Service Bulletin

RRP Service Bulletin No: RRP SB395

Title: Anchormatic 3 (AM3) Work Arm Lock

Product Series: Anchormatic 3

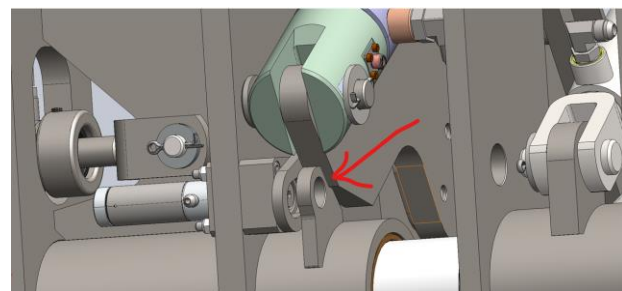
Machines have experienced workarm locks stuck in the unlocked position. This can lead to the workarms falling during track travel potentially damaging the machine.

RRP is currently working on both software protections and an improved lock design. The updated software is version 6.1.10.

Contact RRP for replacement pins (no charge).

Air Locks Not Engaged

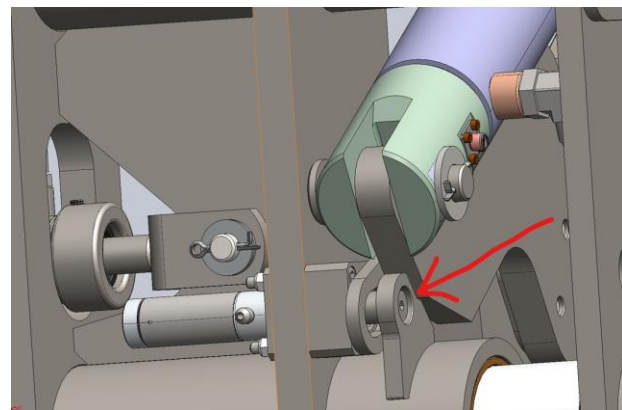
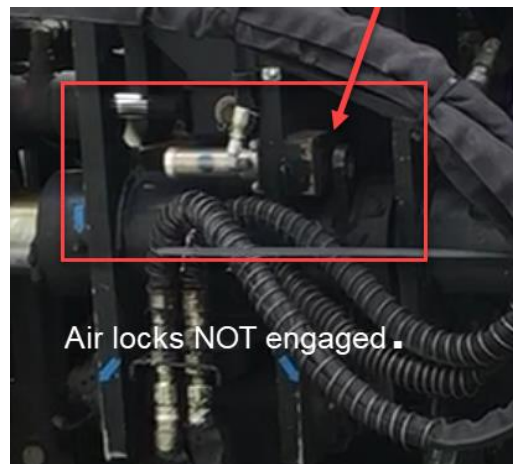
Operators must verify, by visual inspection, that the swing arm locks are engaged correctly before track traveling and when switching from work to travel mode.
